LDCO800 Replacement Parts Compatibility

In August 2010, Linear introduced LDCO800 operator and its field replaceable control board HAE00050. Picture below shows key components to help you identify original LDCO800.

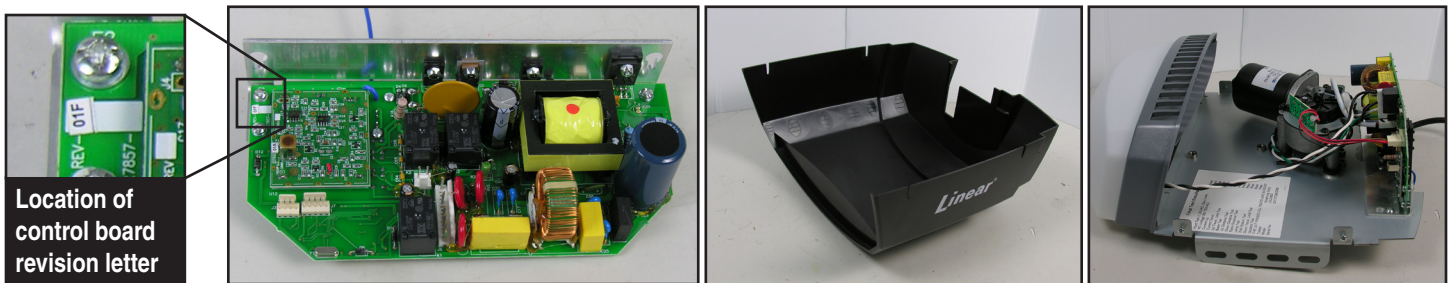
HAE00050 rev A, B, C, D or E

Wrap Cover with Foam

Motor with Boot

Starting with manufacturing date code MD1104 (April 2011), Linear upgraded LDCO800. Linear is introducing **NEW** field replaceable control board part number HAE00060 which is compatible with all of LDCO800. Picture below shows key components to help you identify new upgraded operator.

HAE00060 rev F

Wrap Cover No Foam

Motor No Boot

HAE00050 is discontinued. Use **ONLY** following compatible replacement parts for operator performance and compliance.

LDCO800 Replacement Parts Compatibility		
Replacement Part Description	LDCO800	Upgraded LDCO800
Control Board	HAE00050, HAE00060	HAE00060
Motor with Encoder/Wheel	HAE00053	HAE00057
Encoder	HAE00054	HAE00058
